CHRIST CHURCH BEXLEY

DEVELOPMENT APPLICATION DESIGN REPORT

COUNCIL RFI RESPONSES

08.03.2023

c Childcare centre

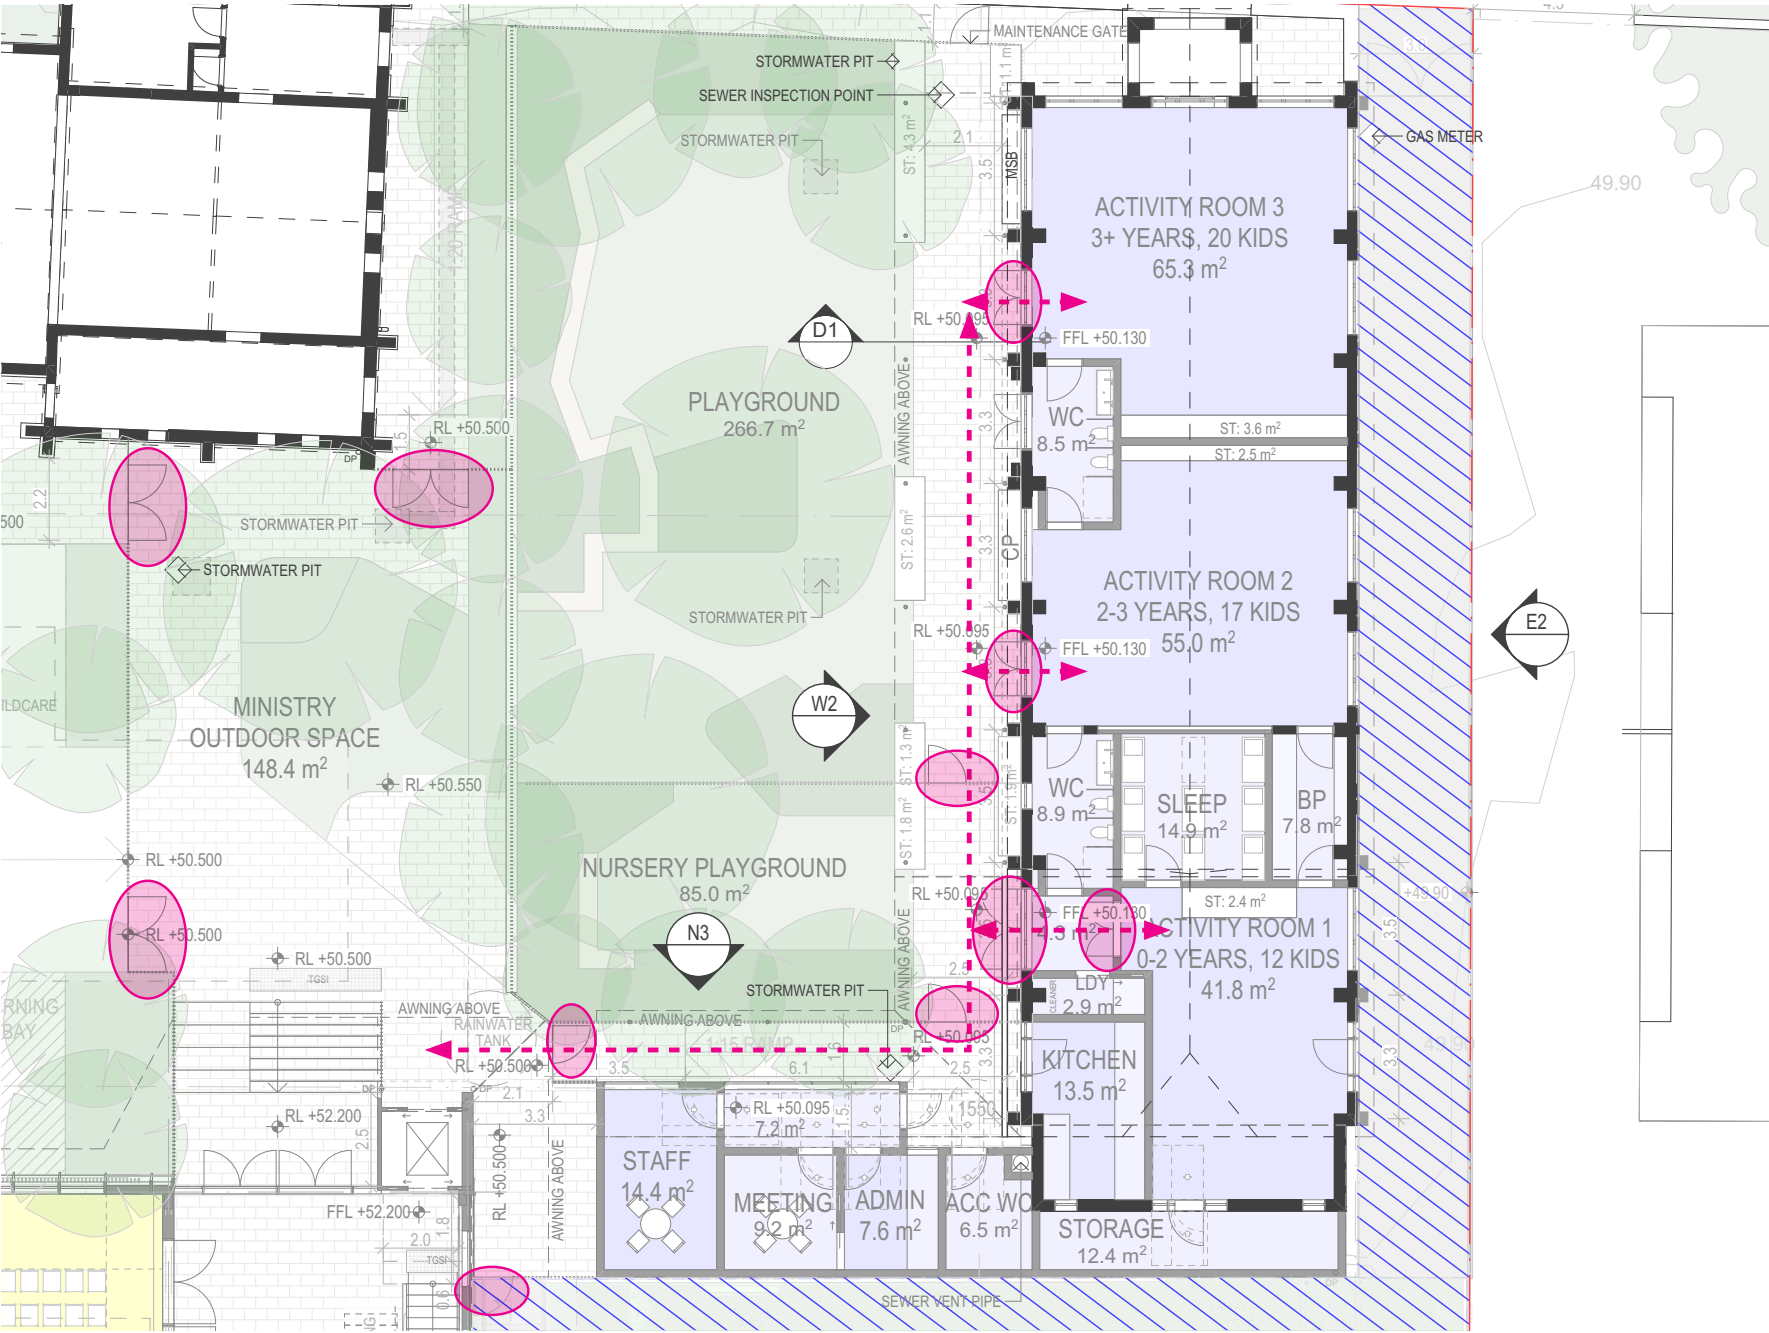
The proposal appears to maintain the shell of the existing church hall. Activity rooms and associated amenities are formed within the building with the introduction of internal partitions. Though this is a sensible response to the existing heritage structure the current configuration of the centre compromises circulation through the centre. Parents accessing children from the 3 plus and 2-3 years are required to walk through the outdoor play area of the 0-2 years play area. At peak drop off and pick up times the gate within the 0-2 external play area will be a busy hub with multiple families entering and exiting the play area simultaneously. This will increase the potential for unaccompanied children to exit the centre unnoticed. Ideally an isolated circulation area should be developed, to allow each childcare room to be accessed without entering the area of a different age group.

RESPONSE

There are 4x control points/gates that a child would need to exit before they will be outside of the childcare centre. Then they would need to exit another gate surrounding the Ministry Outdoor Space before they can access the public footpath and road. We believe this is very adequate security. Refer to diagram below.

d Church

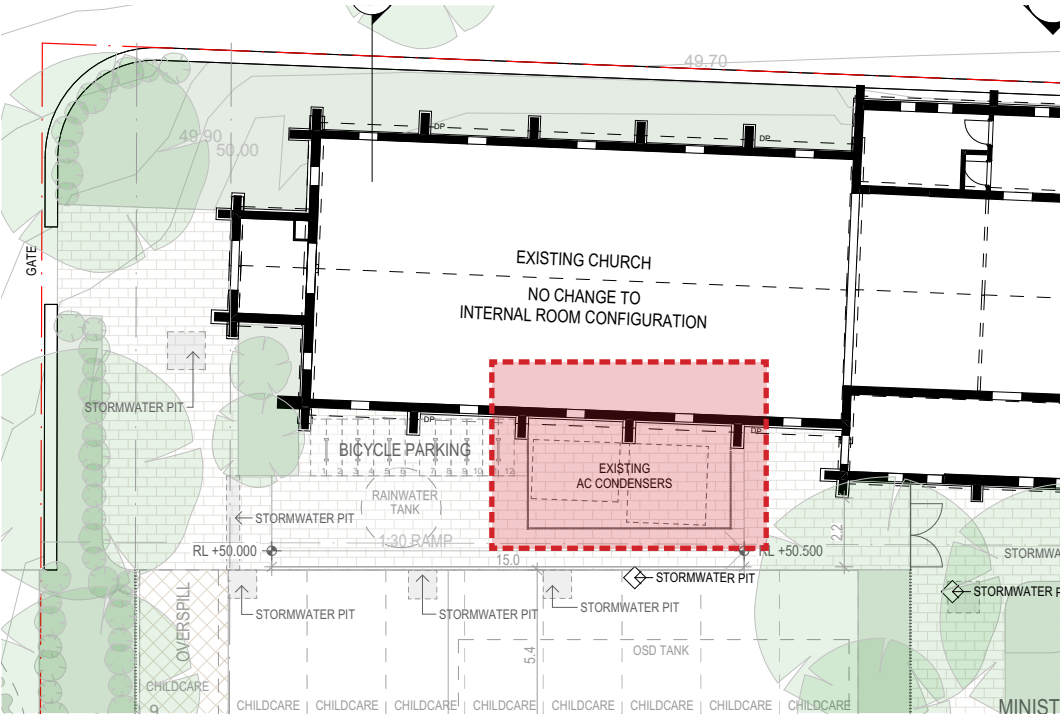
(1) Air conditioning plant is currently located in a prominent location on the southern side of the church. When the proposed development is completed the air conditioning plant will sit in a prominent / highly visible central location. The applicant is encouraged to seek an alternative solution that conceals air conditioning plant in a more discrete location.

RESPONSE

The A/C condensors are existing and the intent is to leave them in place. Refer to enlarged plan and photo below.

Awning Section

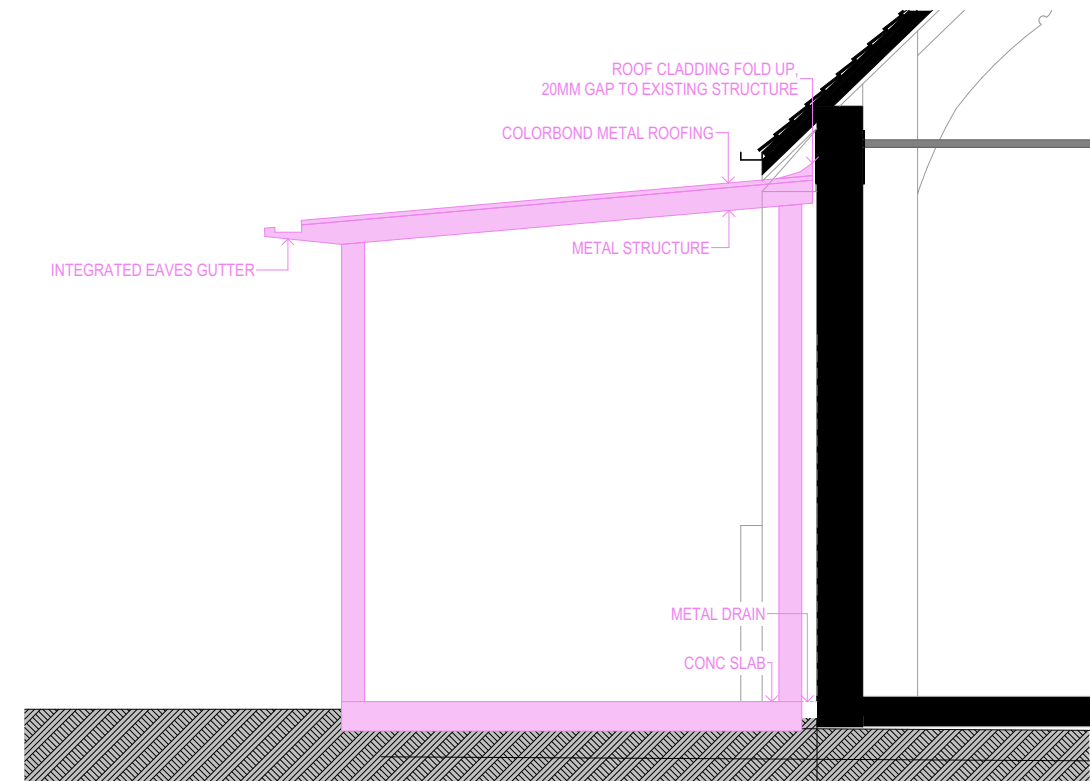
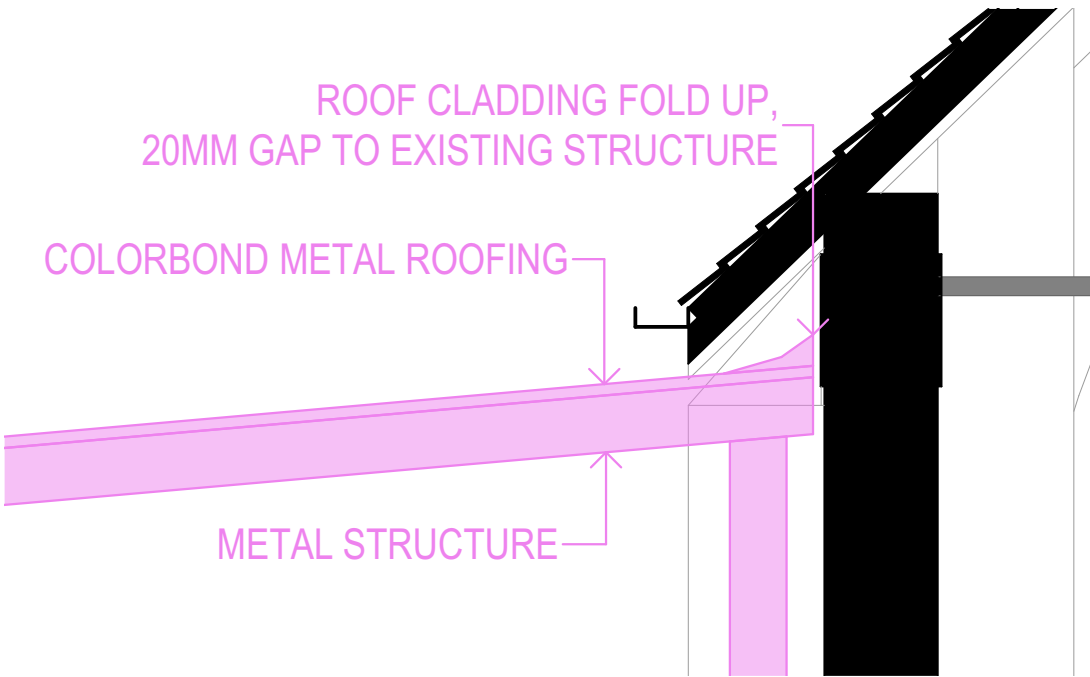
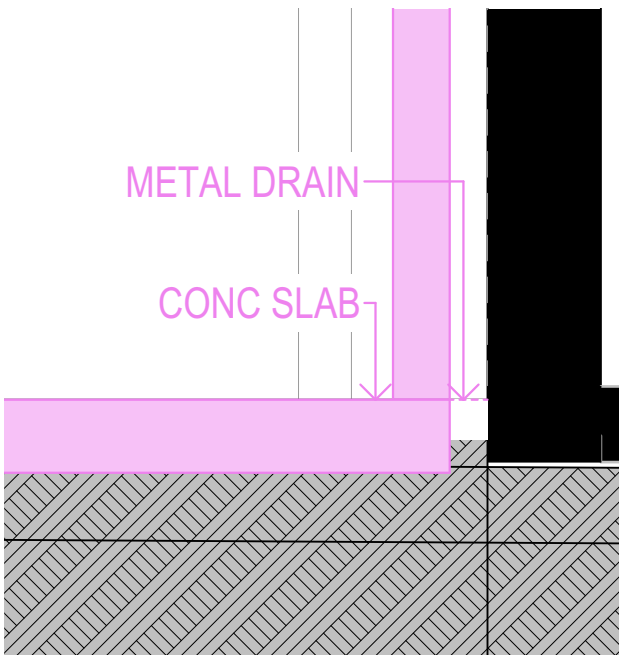
(2) A covered walkway has been proposed to the south western face of the existing hall. From the information provided, it is not possible to determine how the walkway relates to the existing building to maintain the integrity of the existing heritage structure. It is recommended that a detail (1:20 minimum) of the walkway and its interface with the heritage structure is provided.

Refer to details below.

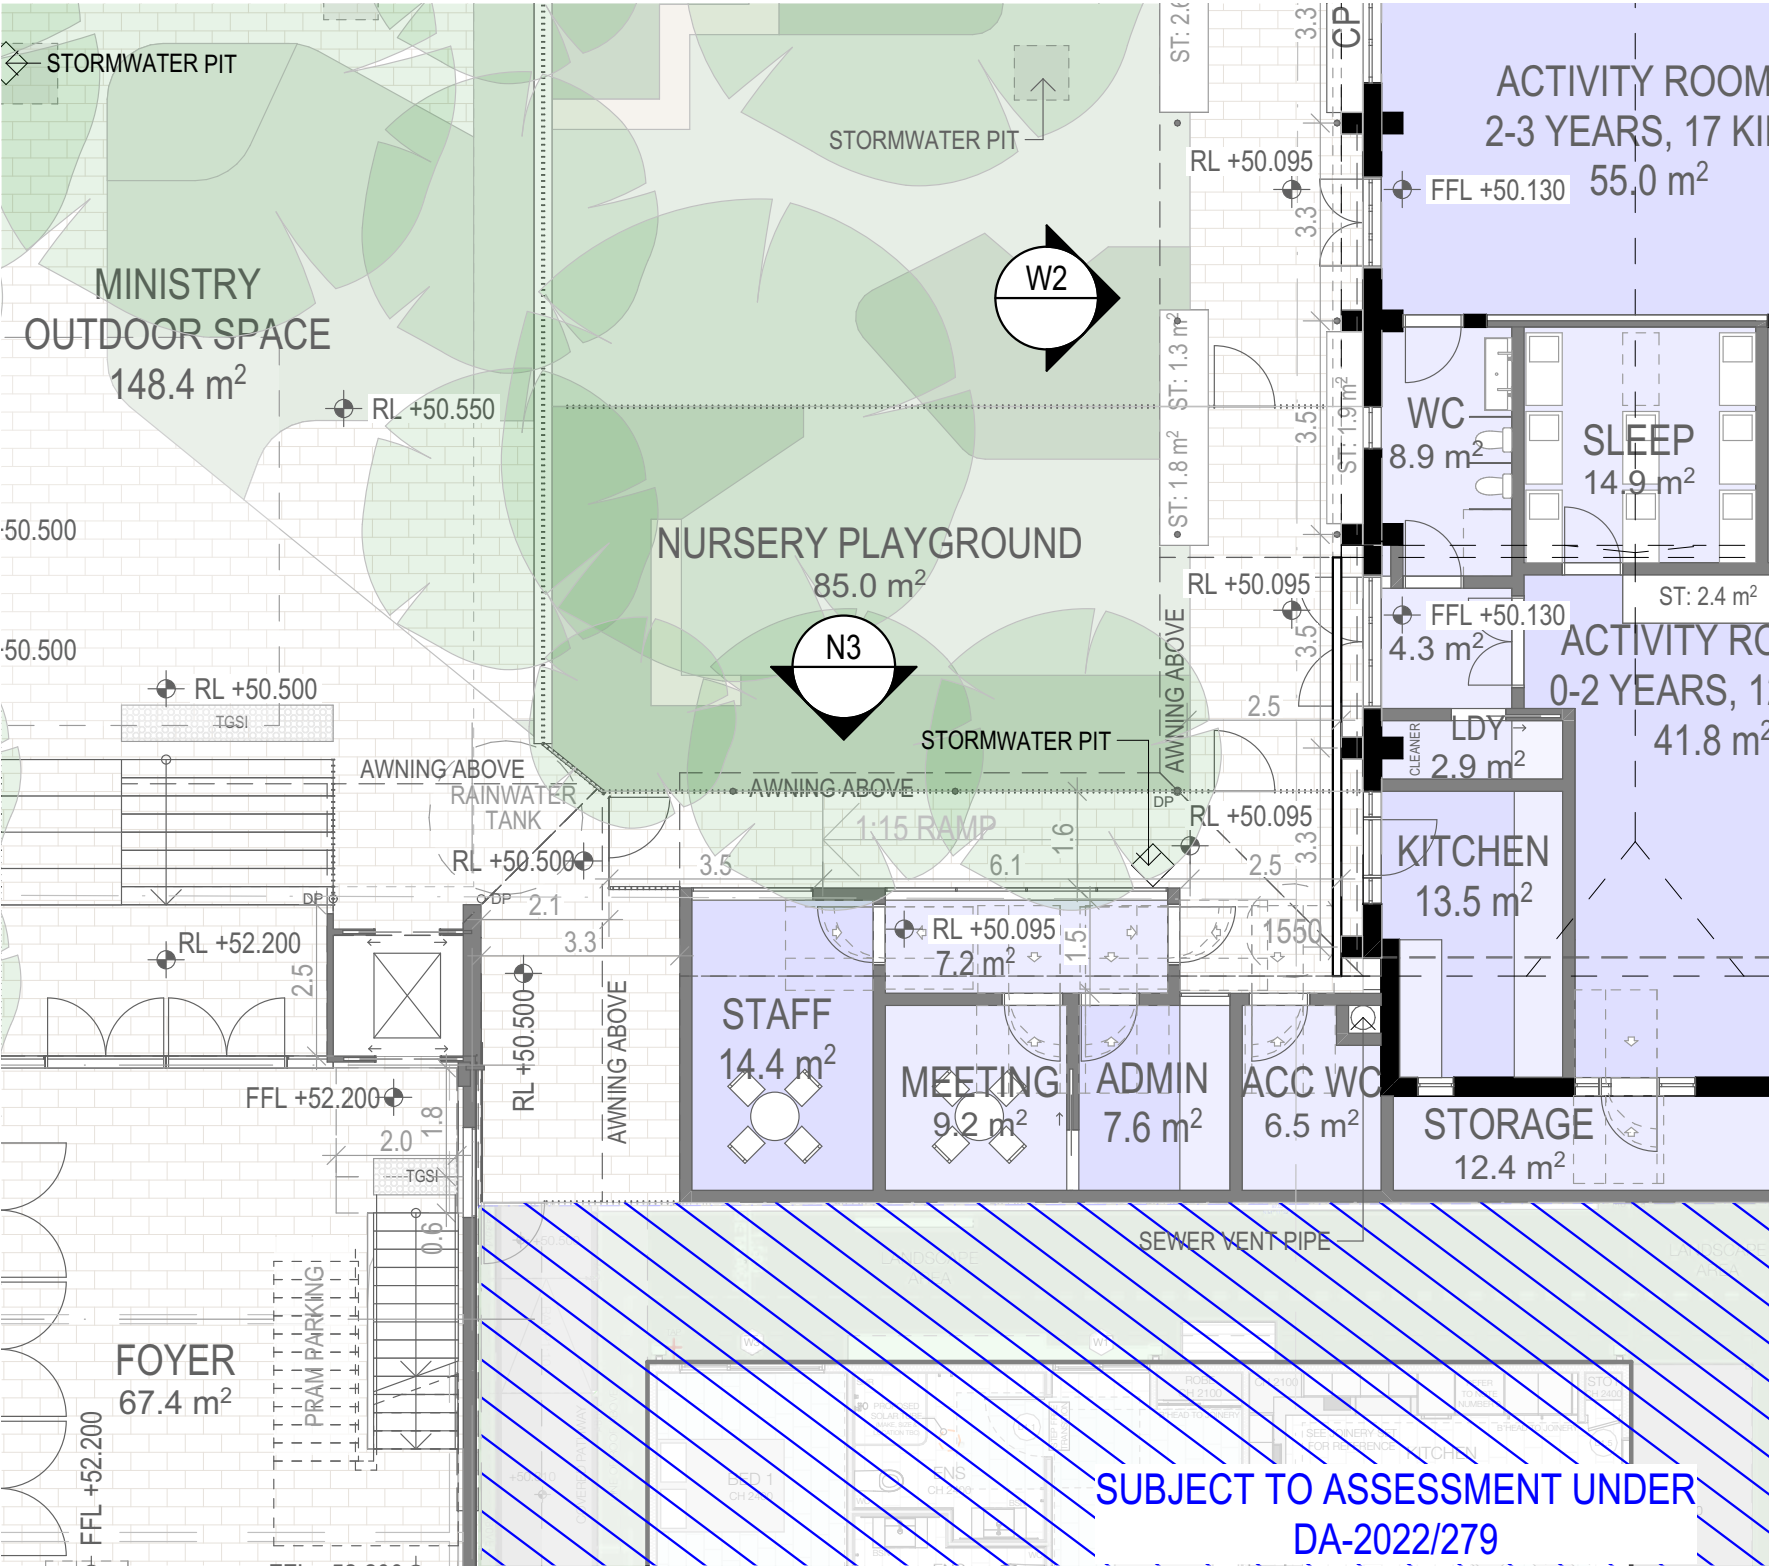
(3) An addition to the hall, providing staff facilities, has been proposed on the southern edge of the hall. The position of the addition appears to be compromising access to the proposed SD dwellings in the eastern portion of the site. Note this issue could be clarified by providing a more detailed master plan for the site (see comments above, site planning).

RESPONSE

Refer to enlarged plan below.

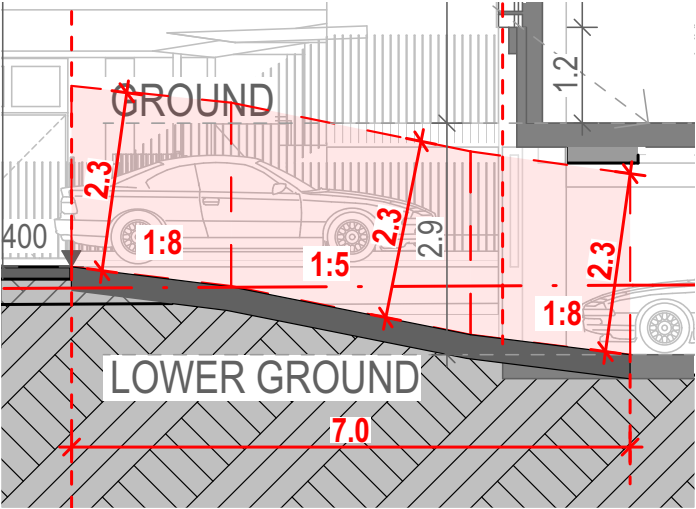
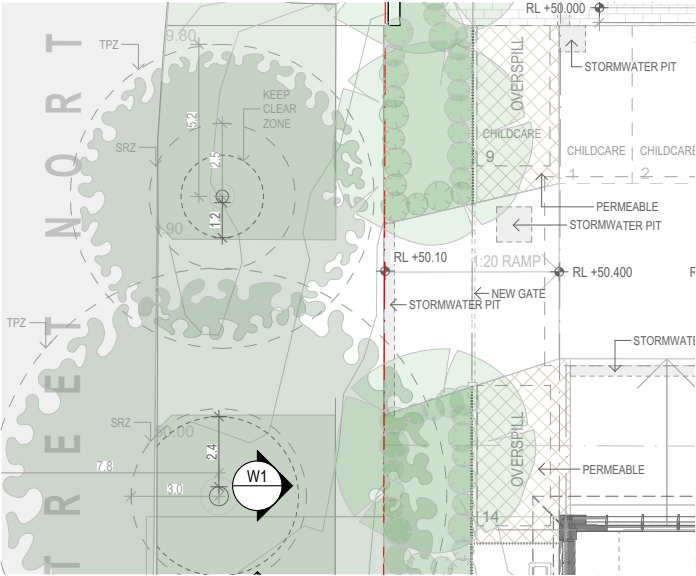
a	Councils’ standard is for driveway crossings to be designed to be perpendicular between the kerb alignment and the boundary alignment. The proposed slanted driveway crossing shall be redesigned to be perpendicular. The slanted driveway shall be provided internally within the property (potentially 1 overspill parking space is to be removed).	Noted, updated in plans. Refer to DA100 Ground floor plan (Refer to enlarged plan below)
b	A longitudinal driveway profile shall be submitted for the basement access ramp. The profile shall be along the critical edge (worst case) of the driveway. Gradients and transitions shall be in accordance with AS2890.1. The profile shall be drawn to a scale of 1 to 25 and shall include all relevant levels, grades (%), headroom clearances and lengths.	<p>The required head clearance is 2.2m minimum; 2.3m has been adopted as advised by the Traffic consultant to allow for: (Refer to enlarged section and AS2890.6 diagram below)</p> <ul style="list-style-type: none">- Gradient changes- Tolerance <p>(Refer to 2b)</p>

SDA van head clearance requirement:

Accessible Parking space head height requirements if mandated under the NCC. Head height requirements also apply to all car parking spaces provided for Fully Accessible and High Physical Support design categories.

Figure 2 (c) Clear head height requirements for AS2890.6 car parking spaces and shared zones and also applicable to car parking spaces allocated to participants in the Fully Accessible and High Physical Support design categories
